Browns Ferry Nuclear Plant, Units 2 and 3
Facility Operating License Nos. DPR-52 and DPR-68
NRC Docket Nos. 50-260 and 50-296

Subject: Technical Specification Change TS-429 – Deletion of Low Pressure Coolant Injection Motor-Generator Sets for Browns Ferry Nuclear Plant, Units 2 and 3

EVALUATION FOR TECHNICAL SPECIFICATION CHANGE TS-429 Deletion of Low Pressure Coolant Injection Motor-Generator Sets for Browns Ferry Nuclear Plant, Units 2 and 3

Figure 1, Current Configuration of Portion of BFN, Unit 2, Electrical Distribution System Associated with Proposed Change

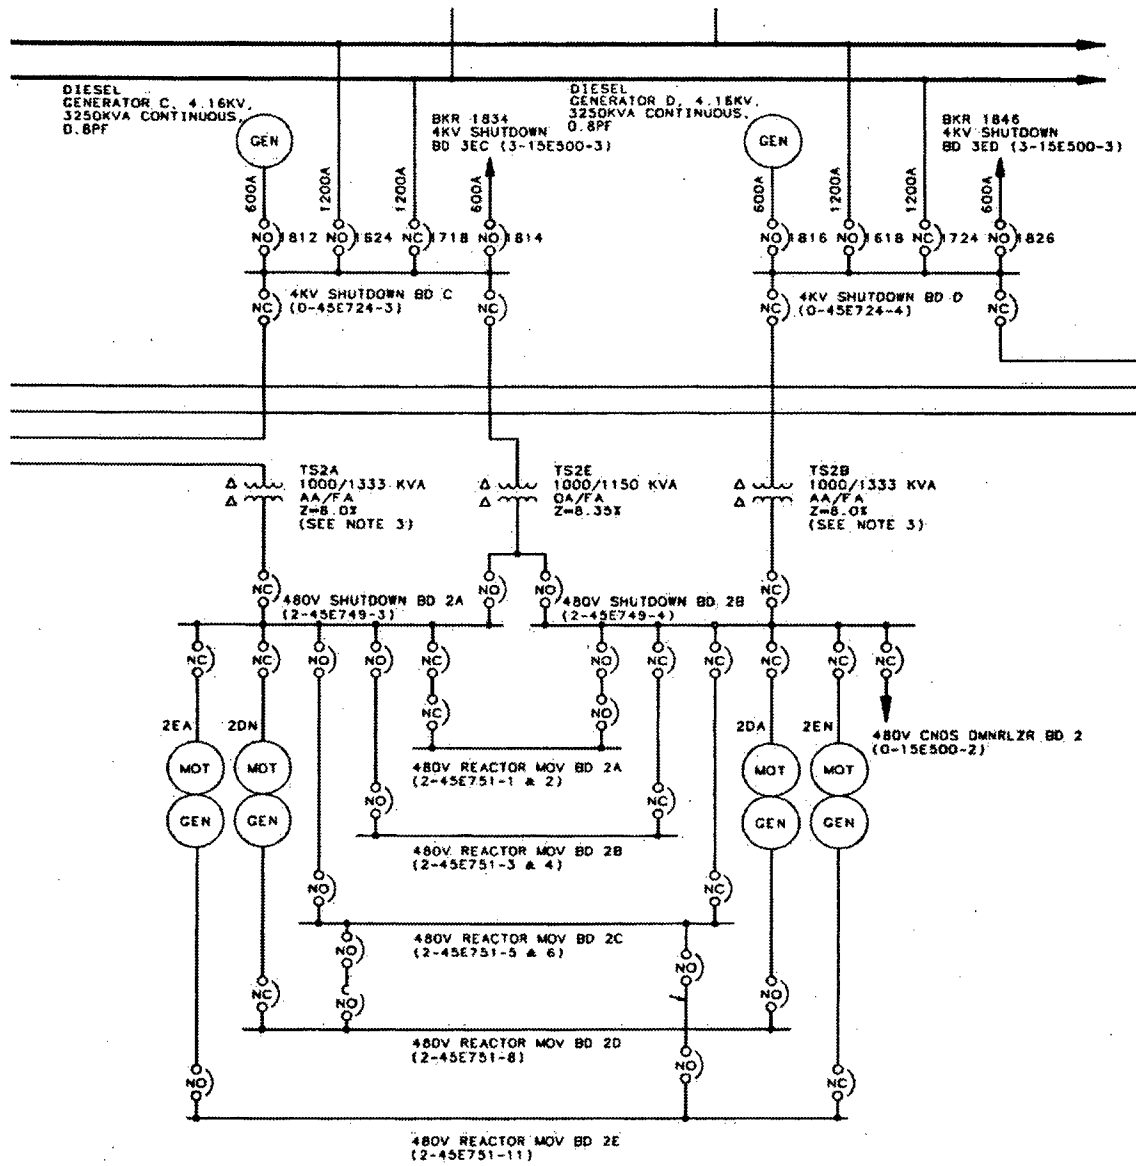
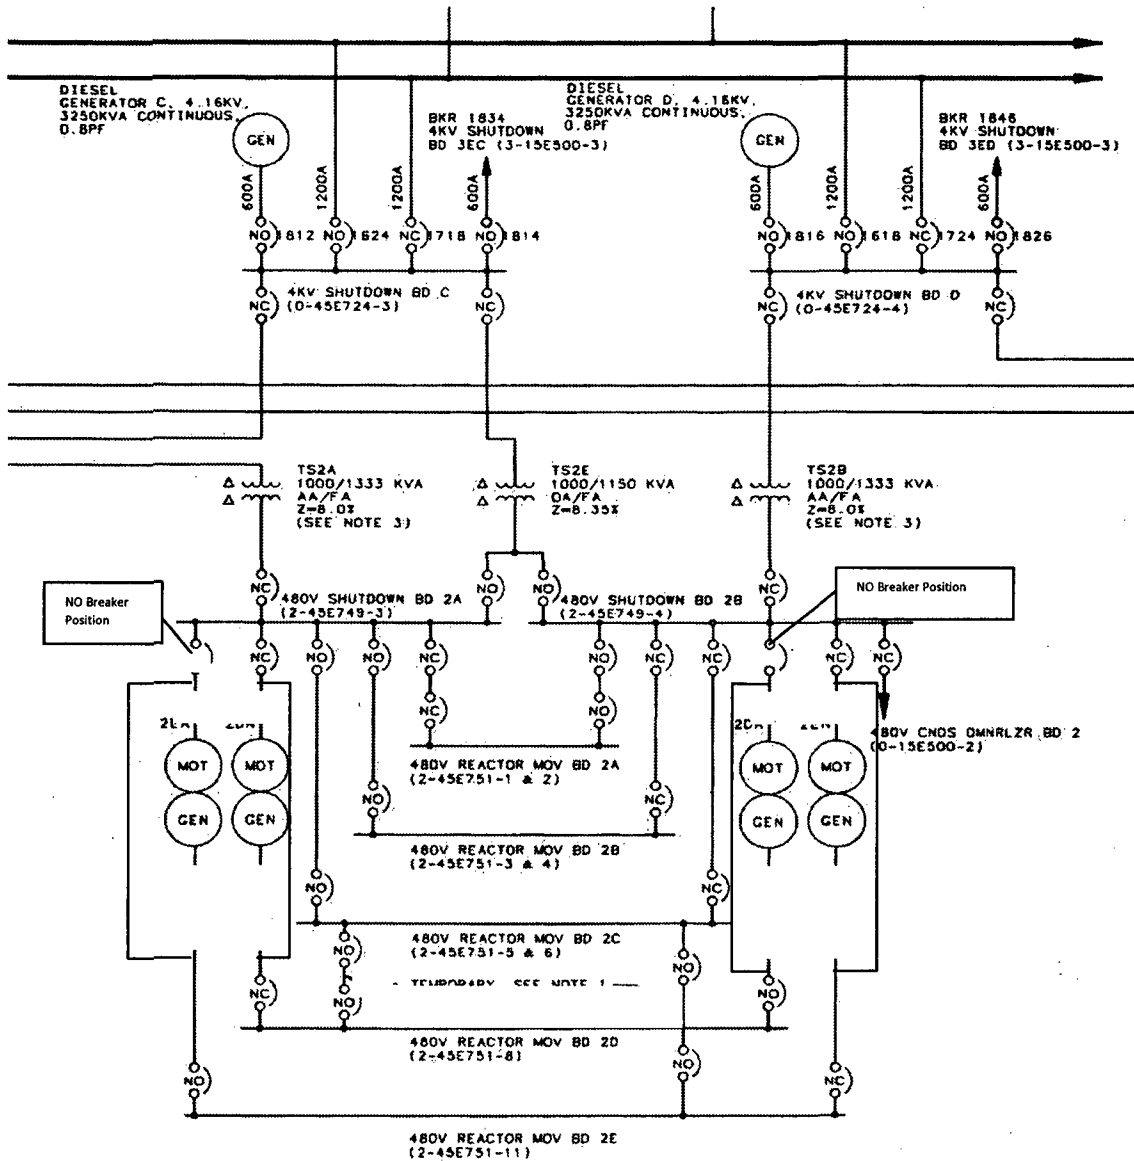
1. BFN, Units 2 and 3, LPCI MG Sets DN, DA, EN, and EA and their locally mounted instrumentation and controls will be removed from service and abandoned in place.
2. Instead of RMOV Boards D and E being powered from the LPCI MG Sets, they will be powered directly from the corresponding 480V Shutdown Boards through their normal feeds.
3. The feeder breakers for 480V RMOV Boards D and E at the applicable 480V Shutdown Boards will be modified from electrically operated to mechanically operated.
4. The alternate feeder breakers for 480V RMOV Boards D and E at the applicable 480V Shutdown Boards will be changed from normally closed to normally open.

The current configuration of the portion of the electrical distribution system associated with this proposed change is shown in Figures 1 and 3 for BFN, Units 2 and 3, respectively.

After the proposed change, the resulting configuration of the portion of the electrical distribution system associated with this proposed change will be as shown in Figures 2 and 4 for BFN, Units 2 and 3, respectively.
